<b>TECHNICAL BULLETIN</b>		<b>Mfg:</b> GM
	<b>July 2006</b>	<b>Model:</b> C-SERIES
	<b>TB 2367</b>	<b>Liter:</b> 6.6L
		<b>V I N:</b> 1
		<b>Year:</b> 01-04

Revised Main Bearing Bolt For  
2001-2006 GM 6.6L VIN 1 & 2 Diesel Engines

## Bulletin Diagram: FIGURE 1. BOLT HEAD DIFFERENT APPEARANCES - CYLINDER BLOCK

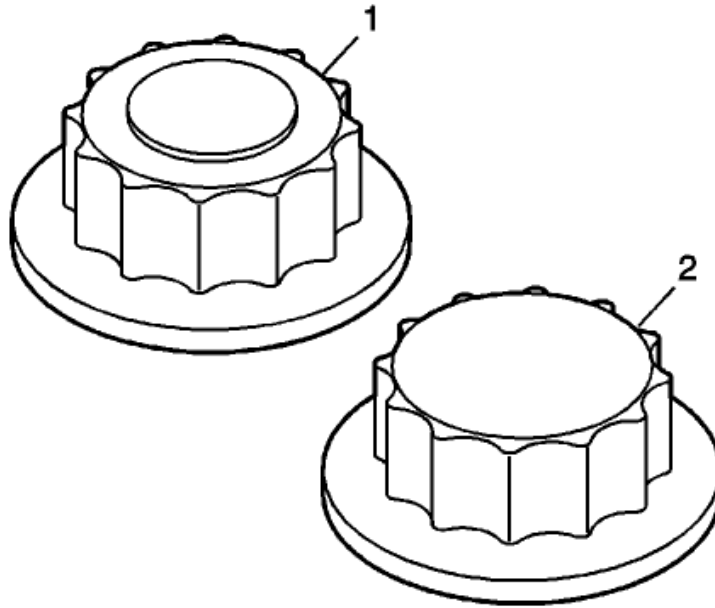
The AERA Technical Committee offers the following information regarding a revised main bearing cap bolts for 2001-2006 GM 6.6L diesel engines. During the early production of 2006 Duramax™ diesel engines, a design change was made to the bearing cap bolt and bore for increased durability.

This change includes a .150" (4 mm) longer main bearing cap bolt along with a deeper tapped hole and a deeper counter bore. The new bolt can be identified by a raised circle formed into the bolt head as shown in Figure 1 below.

Use of the incorrect bolt will result in engine damage. The shorter bolt will not have enough thread engagement in the newer blocks due to the deeper counter bore, and the longer bolts will bottom out in the older blocks before achieving the proper clamp load. Measurement of the bolt length is not a reliable method of identifying the bolt, as the bolts will stretch to a varying degree after installation. The main bearing cap bolts should not be reused in service.

When performing service work on ANY model year Duramax™ engine, the main bearing cap bolts must be replaced with the same type of bolt that was originally installed. Use the raised circle identifying mark on the bolt head to determine which bolt to use.

**Bulletin Diagram: FIGURE 2. BUILD DATE CODE LOCATION - CYLINDER BLOCK**

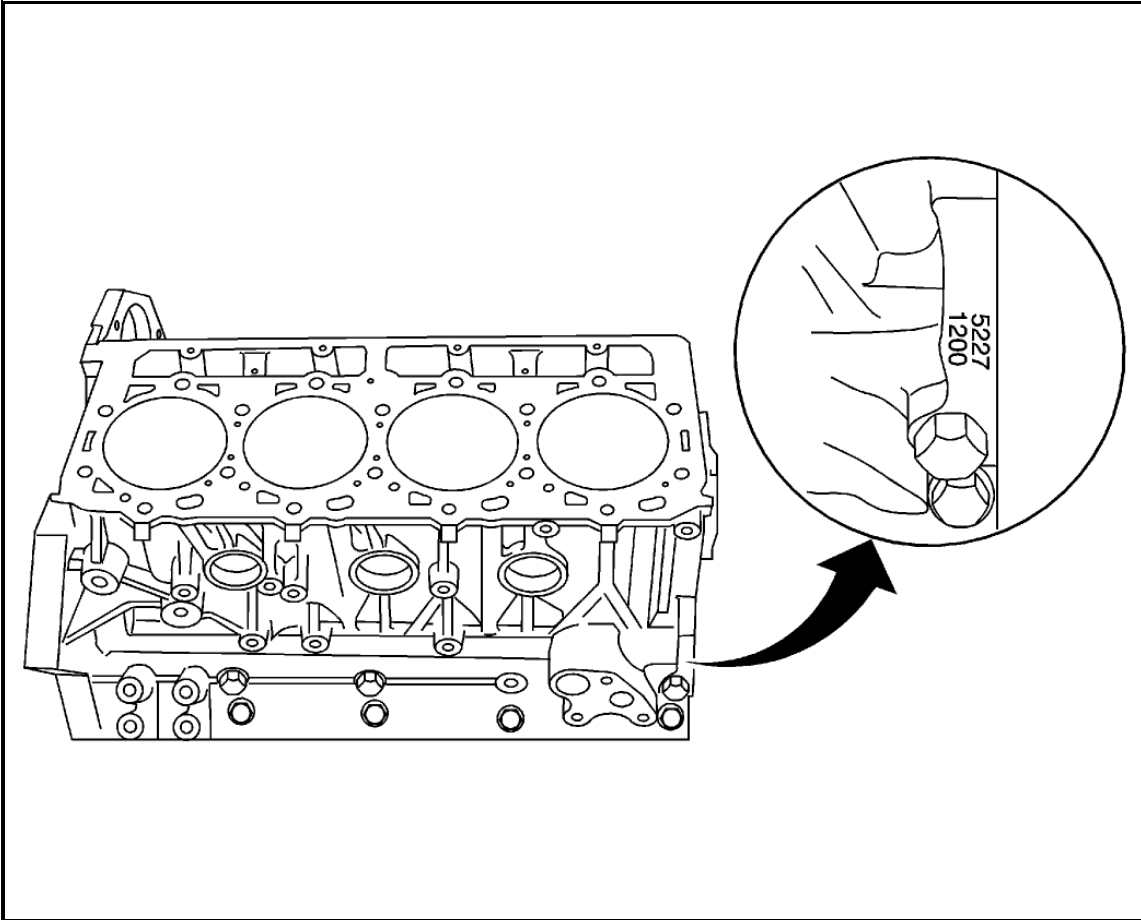
In the event that the raised circle identifying mark on the bolt head cannot be relied upon to determine the correct bolt usage, the engine block production date/time stamp may be used.

The above engine block graphic illustration shows the location of the block's production date/time stamp behind the oil cooler. This date and time indicates the beginning of usage for the longer main bearing cap bolt. Any block built before this time will require the shorter bolt. The production date and time in the above illustration can be determined as follows:

5227 = 2005, 227th day (August 15)  
1200 = 1200 hours (12 PM)
